DOE/EIS-0245F

ADDENDUM
(FINAL ENVIRONMENTAL IMPACT STATEMENT)

Management of Spent Nuclear Fuel from the K Basins at the Hanford Site, Richland, Washington

January 1996

Figure 3-11. Summary schedule for the foreign processing alternative (Bergsman et al. 1995)

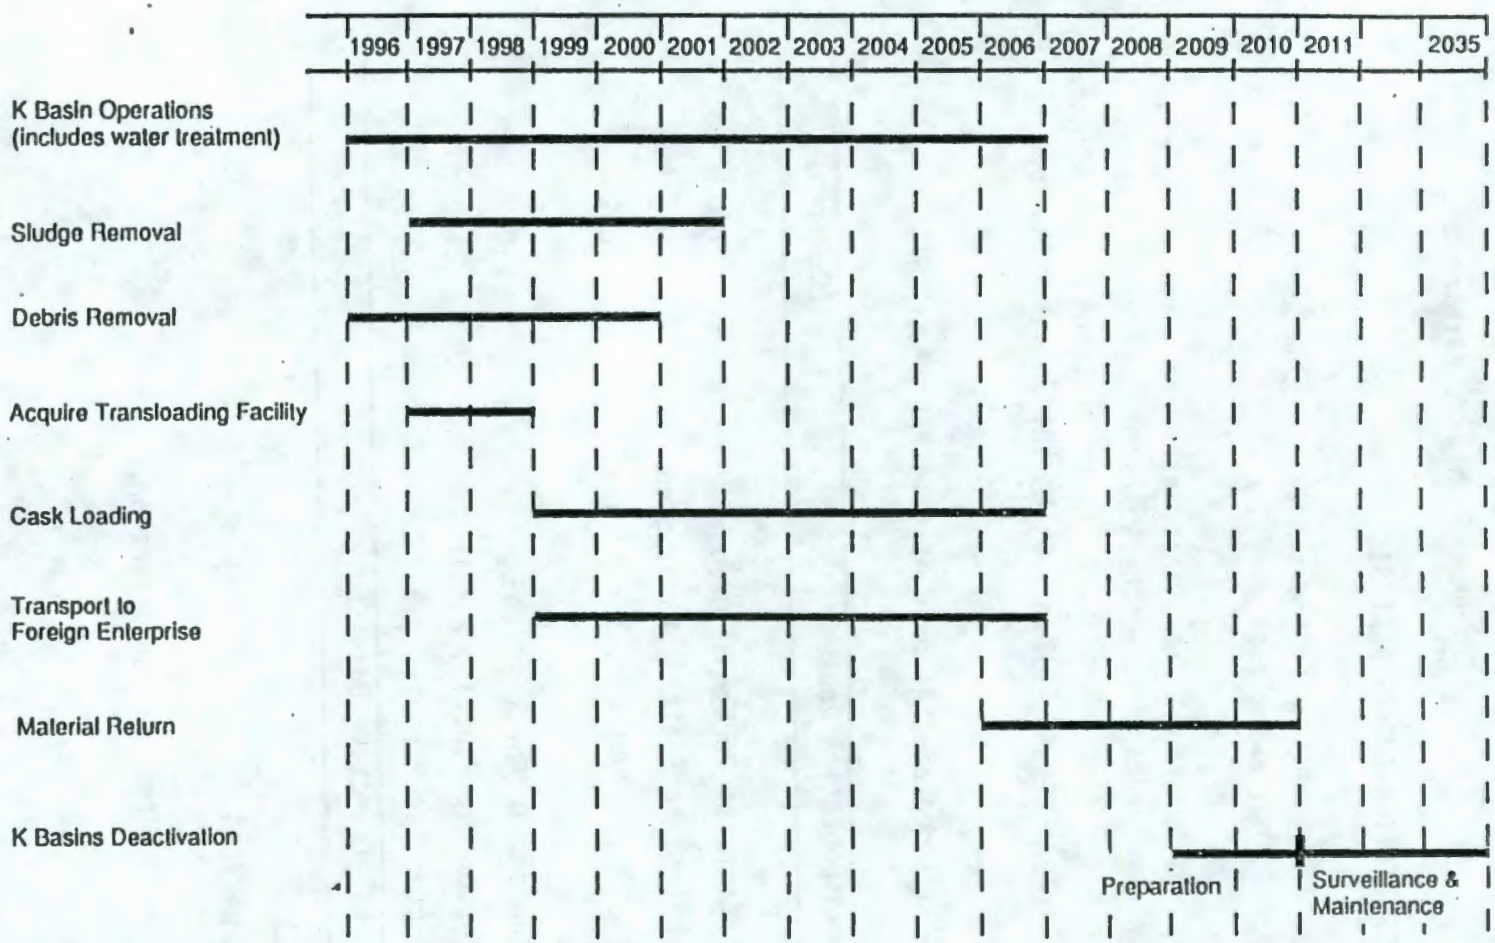
L09-C07. Pages 3.40 - 3.42 - "Packaging, Transport and Processing." The nine year period for shipment of fuel for foreign processing is excessive. There is no transport constraint which dictates this long a program. Seven years can be achieved easily, and given sufficient casks, the fuel can be transported as quickly as it can be removed from the basin (i.e., on the same timescale as any other option). The figure used for number of shipments

(4000) has to be a typographical error. BNFL's estimates assumed 600 shipments, on the basis that the shipments would be completed in 5-7 years (not the 9 years shown in Figure 3.11).

The figure used for number of shipments (4000) has to be a typographical error! BNFL's estimates assumed 600 shipments, on the basis that the shipments would be completed in 5-7 years (not the 9 years shown in Figure 3.11).

Page 3.40, first paragraph after bullet list, second sentence - change to read "The schedule in Figure 3-11 assumes maximum cask payloads and three shipments a year with 24 casks per shipment, for a total of 576 cask loads in 24 shipments to remove all the SNF from the K Basins."

Page 3.41, Figure 3-11 - replace with corrected Figure 3-11.

Figure A-9. Proposed calcination facility (Bergsman et al. 1995)

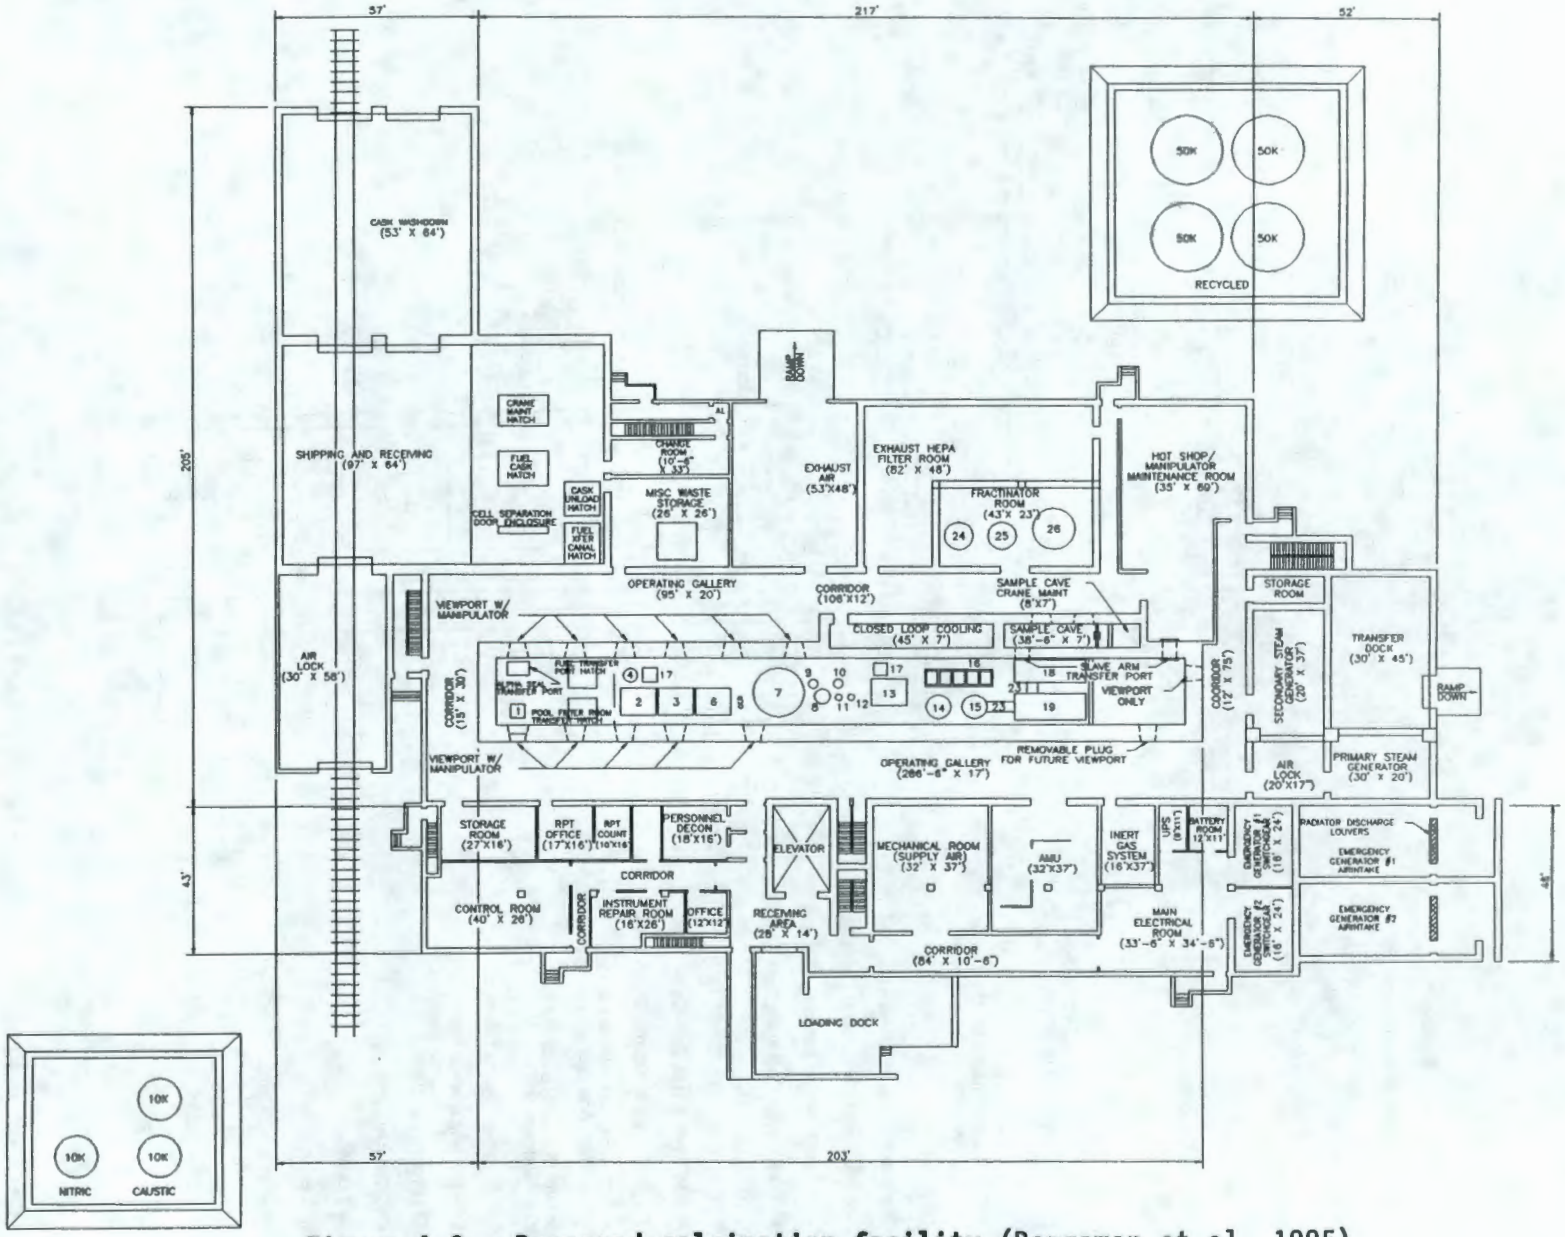
L05-C22. Page A.21, Fig. A-9. Locations within Figure A-9 are numbered; however, the numbers are not explained in a legend. For purposes of understanding, it is helpful to have a legend.

Page A.21, Figure A-9
Locations within Figure A-9 are numbered, however, the numbers are not explained in a legend. For purposes of understanding, it is helpful to have a legend.

R. Figure A-9 is incorrectly labeled. The correct Figure A-9 is provided in the Errata section of this Addendum. These figures were intended to indicate the scope and complexity of the facilities, not to provide details of the design.

Page A.21, Figure A-9 - replace with correct Figure A-9, attached.

Figure A-11. Proposed onsite processing facility

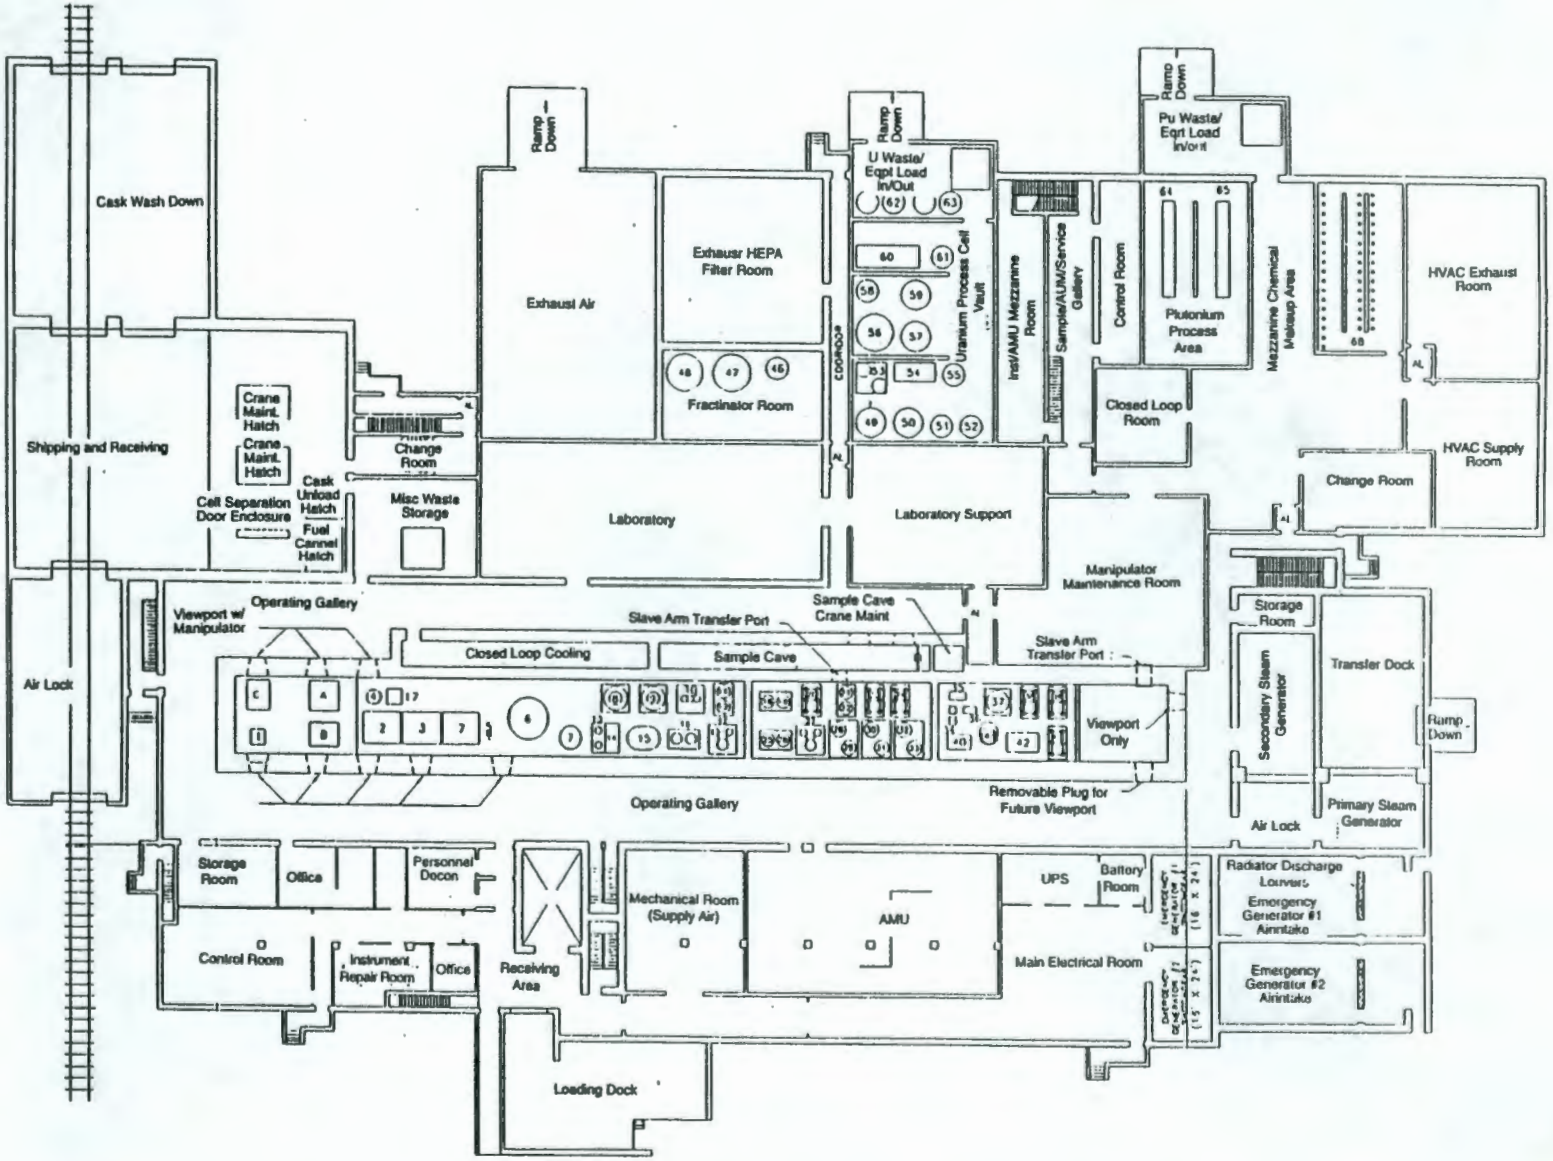
L05-C23. Page A.24, Fig. A-11. We would like to know the locations of positions 24, 26, and 27 not shown on the figure. Also, what is the purpose of a cold trap as shown at position 12? Information like this is important in evaluation of K-Basin alternatives.

Page A.24, Figure A-11
We would like to know locations of positions 24, 26 and 27 not shown on the Figure. Also, what is the purpose of a cold trap as shown at position 12? Information like this is important in evaluation of K-Basin alternatives.

R. Item 24 is below the elevation of the figure. It extends to the north from item 3 to item 2. Items 26 and 27 are on the second floor of the building above the elevation of the figure. Item 26 is above item 7. Item 27 is nominally above items 4 and 22. The cold trap is to condense gases released during SNF processing. This figure was incorrectly labeled in the Draft EIS; it actually depicts the proposed conditioning facility. The correct figures are provided in the Errata section of this Addendum.

Page A.24, Figure A-11 - replace with correct Figure A-11, attached.
